THM 4L60-E/4L65-E "UPDATE HANDBOOK"

THM 4L60-E/4L65-E

THM 4L60-E TCC "PWM" SOLENOID ADDED IN 1995 AND NEW OIL PUMP ASSEMBLY FOR 1995

Figure 1

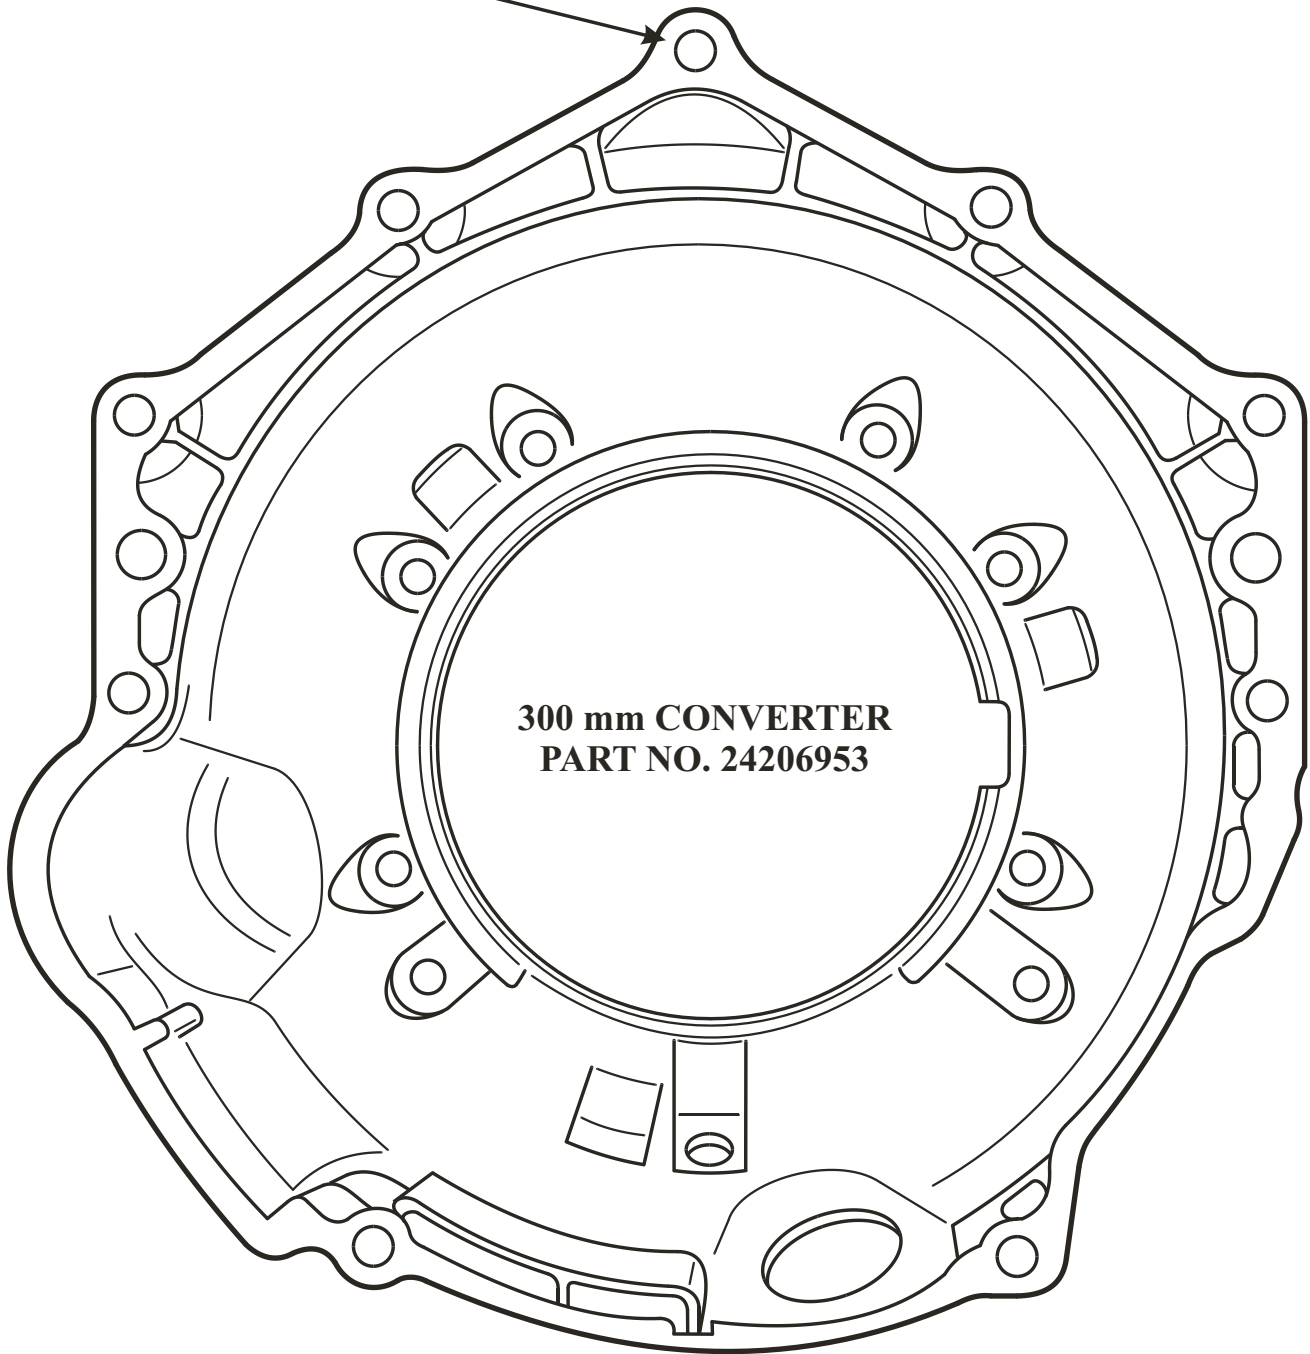
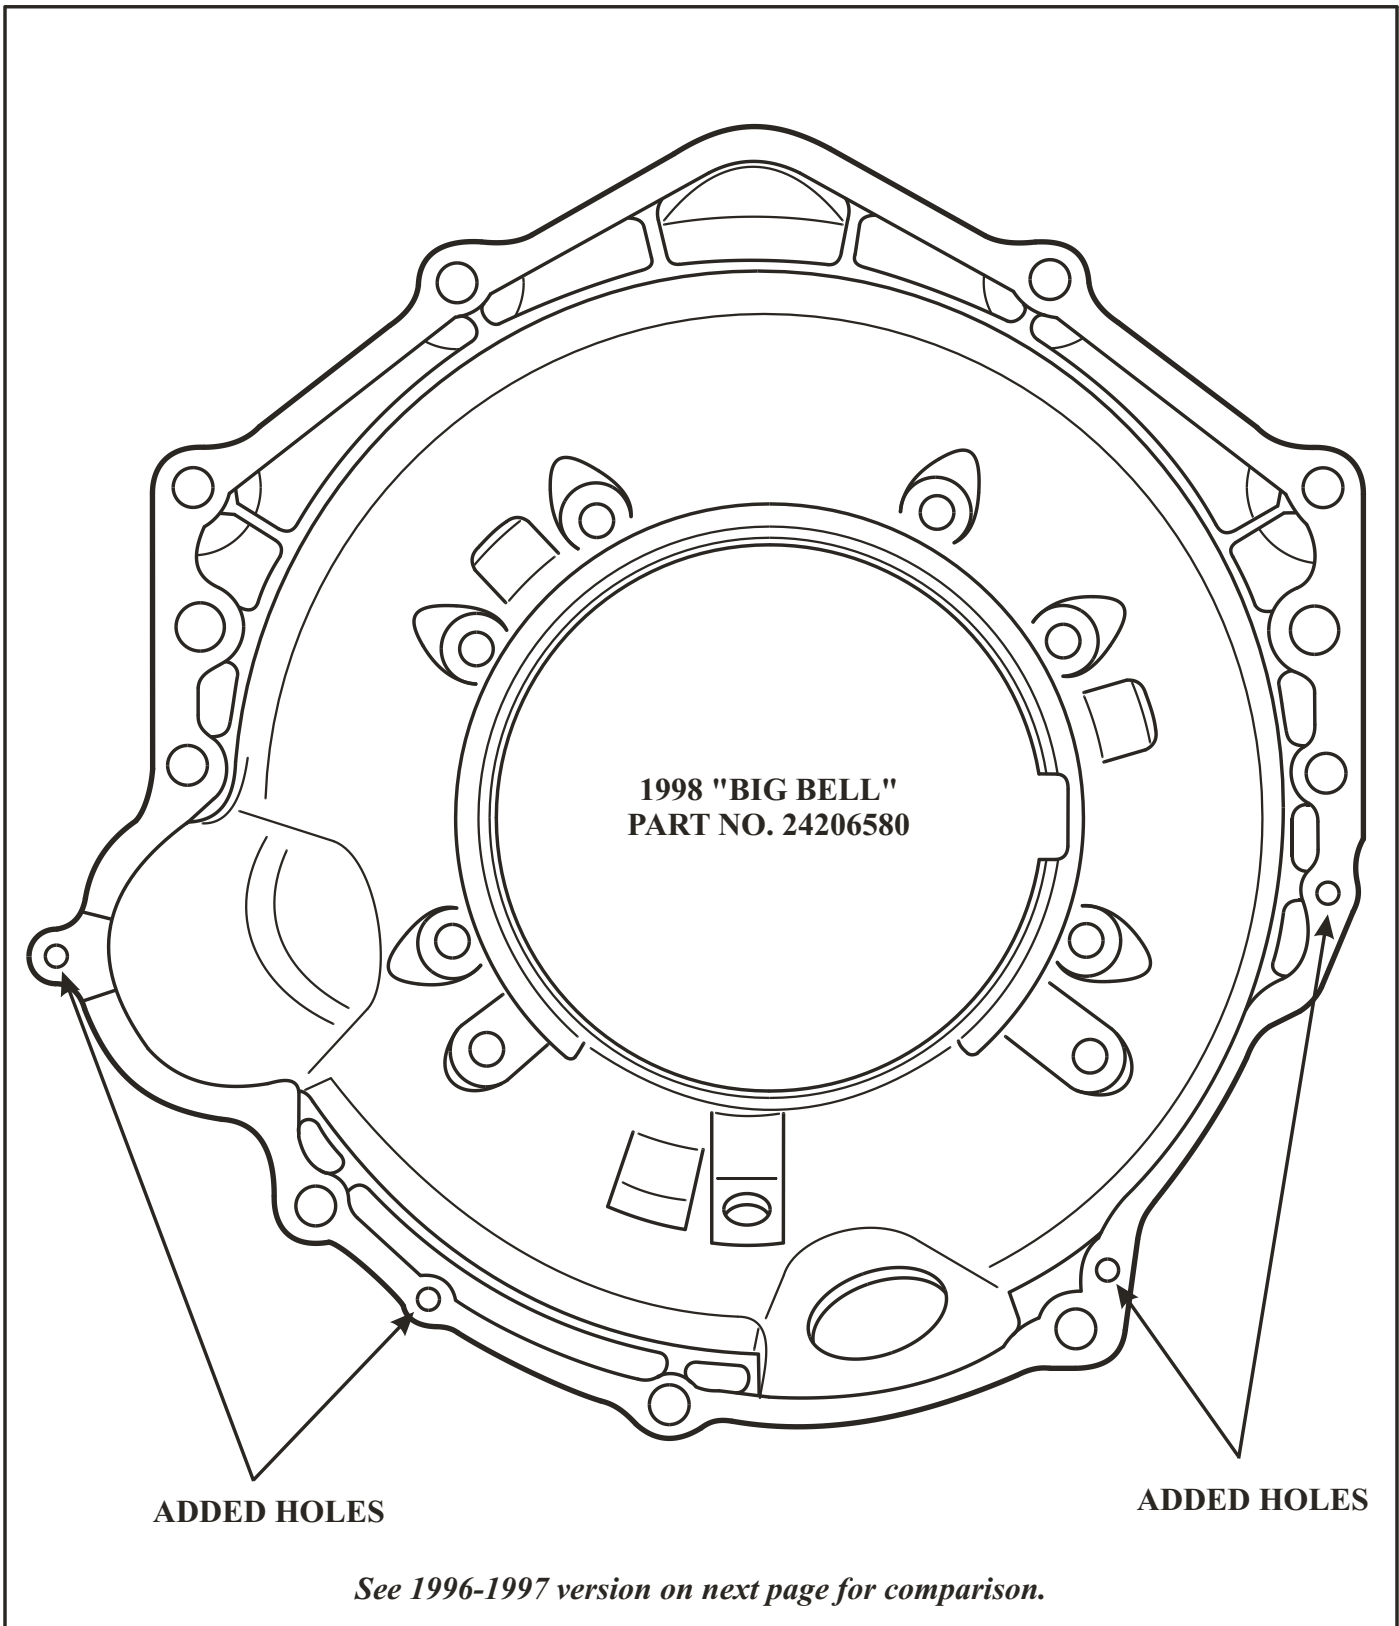
The Bellhousing shown in Figure 1, is approximately 1/4" deeper than the previous "Big Bell" and is designed to accommodate a new 300mm converter that is used in the 1998 Firebird and 1999 C & K Trucks. The best identification is the added bolt hole at the top of the bellhousing. This style bellhousing and the 300mm converter also require a new design turbine shaft and stator shaft that are also about 1/4" longer.

**ADDED BOLT HOLE AND
IS APPROX. 1/4" DEEPER**

This style bellhousing and the 300mm torque converter also require a new design turbine shaft and stator shaft that are approximately 1/4" longer than other models.

Figure 1

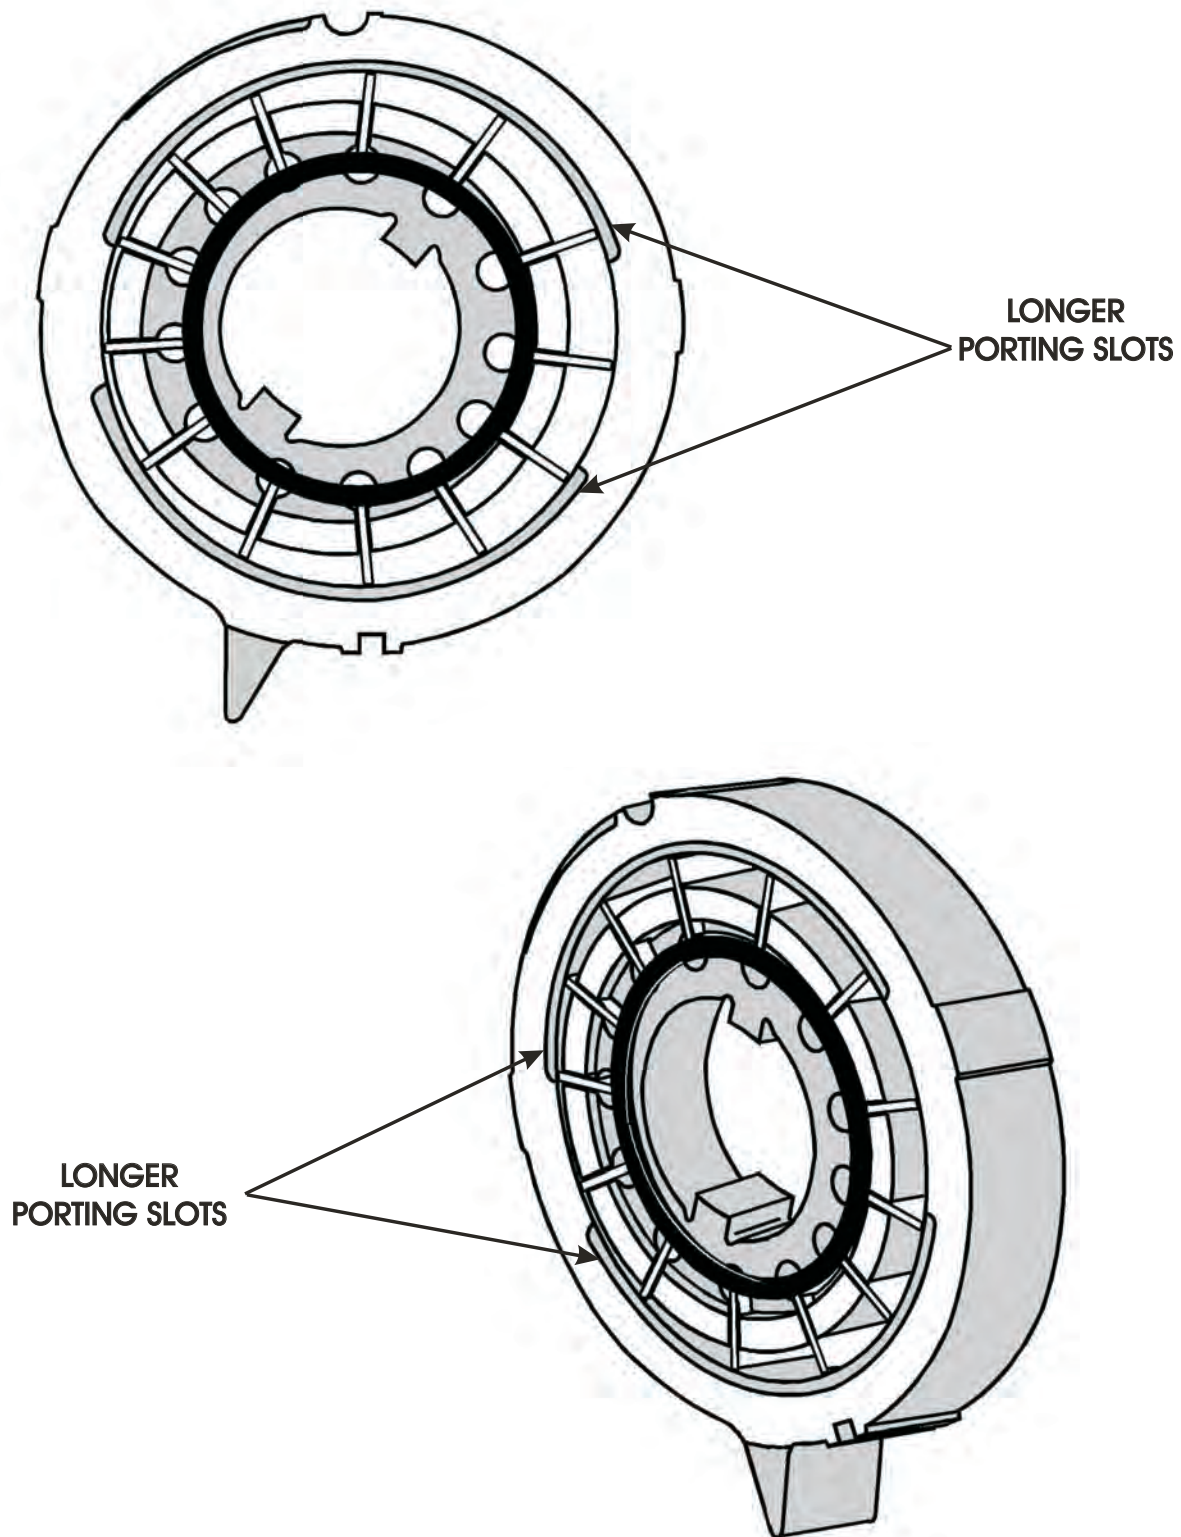
- (1) OIL PUMP ROTOR - Now has 13 vanes in the pump rotor instead of the previous 10 vanes, as shown in Figure 1.
- (2) OIL PUMP SLIDE - Now has longer porting slots on the face of the slide (See Figure 1).
- (3) ROTOR GUIDE - Now has 13 slots in the rotor guide to accommodate the added vanes.
- (4) OIL PUMP COVER - Now has different configuration on the porting slots in the pump cover to accommodate the changes in the pump slide (See Figure 2). The 13 vane pump cover can be easily identified with "13 V" cast into the back side in the location shown in Figure 3.
- (5) VANE RINGS - Material change to increase vane ring durability.

Figure 3

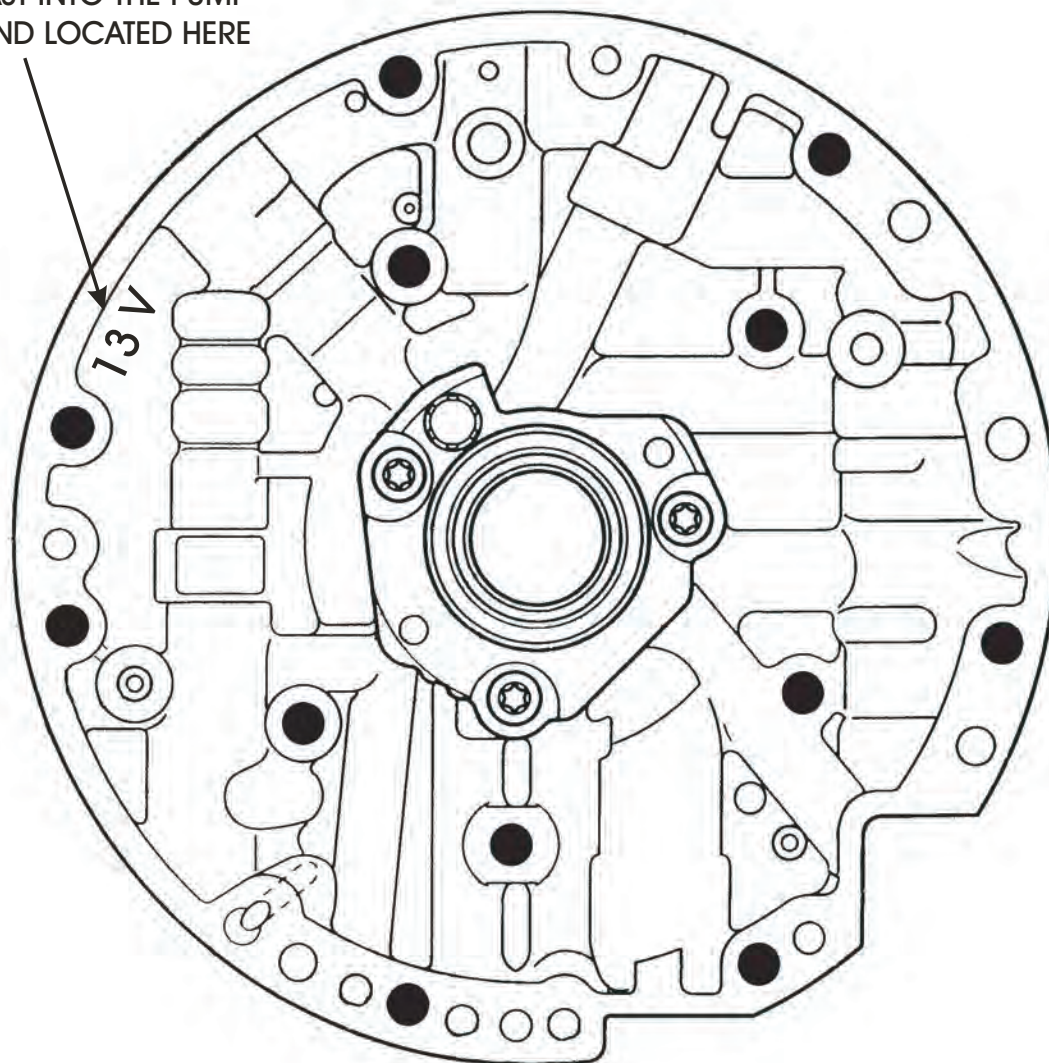
"13 V" CAST INTO THE PUMP
COVER AND LOCATED HERE

***THIS PUMP COVER WILL NOT INTERCHANGE WITH PREVIOUS MODELS.
IT MUST BE USED WITH THE 13 VANE ROTOR AND SLIDE.***

Figure 1

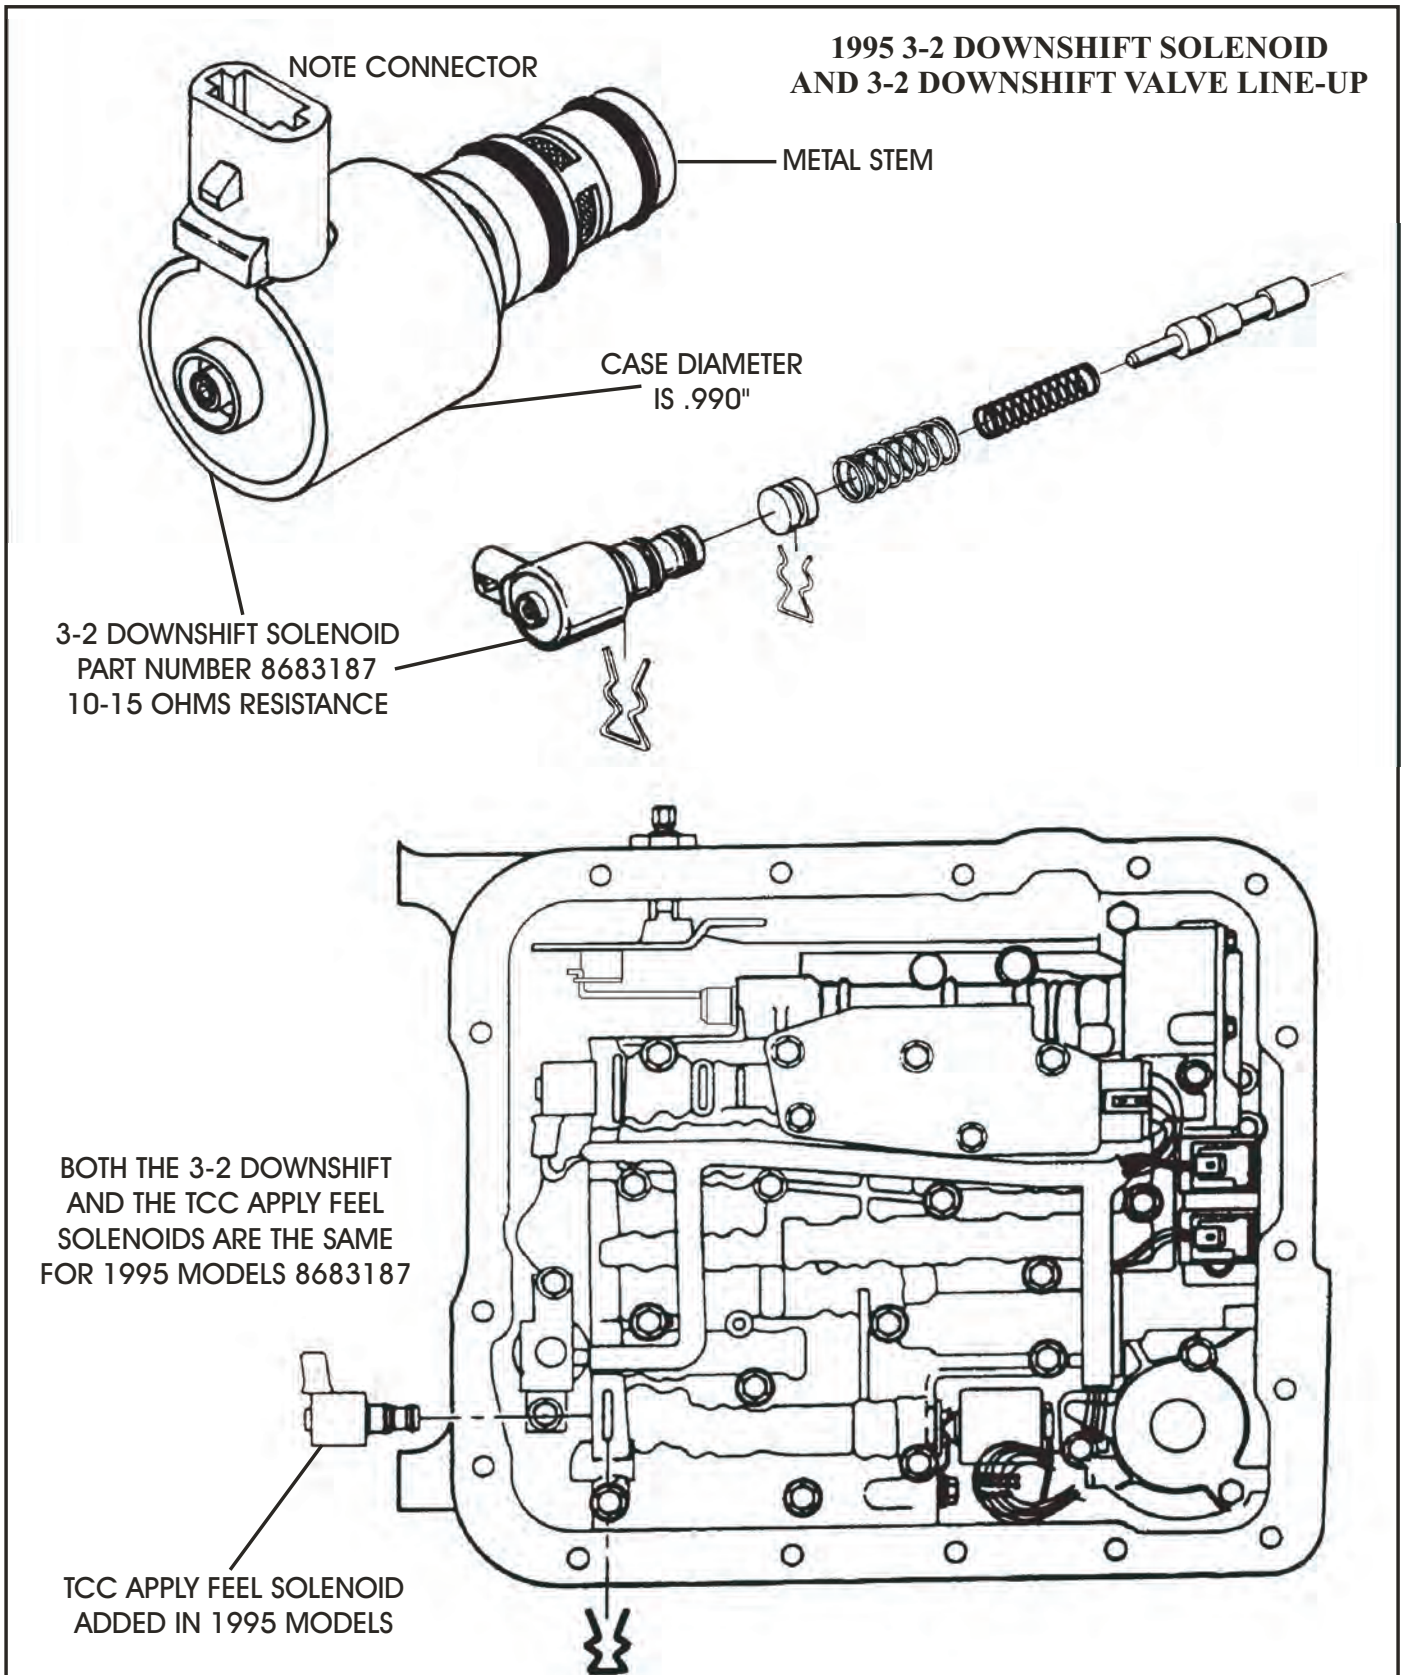
- (1) 3-2 DOWNSHIFT SOLENOID - Changes from a Pulse Width Modulated (PWM) solenoid to a regular "On-Off" (Normally Open) solenoid, which also requires a different Powertrain Control Module (PCM). The new design "On-Off" 3-2 downshift solenoid can be identified by the case diameter, which is smaller than the previous design, and the new design solenoid also has a *plastic* stem that fits into the valve body bore, where the previous design was *metal*.
The solenoid connector was also changed to prevent the solenoids from being accidentally installed in the wrong models. Refer to Figure 1 for 1995 models, and Figure 2 for 1996 models.

- (2) 3-2 DOWNSHIFT VALVE - The entire 3-2 downshift valve line-up changes to accommodate the new design "On-Off" 3-2 downshift solenoid. Refer to Figure 1 for 1995 models, and Figure 2 for 1996 models.
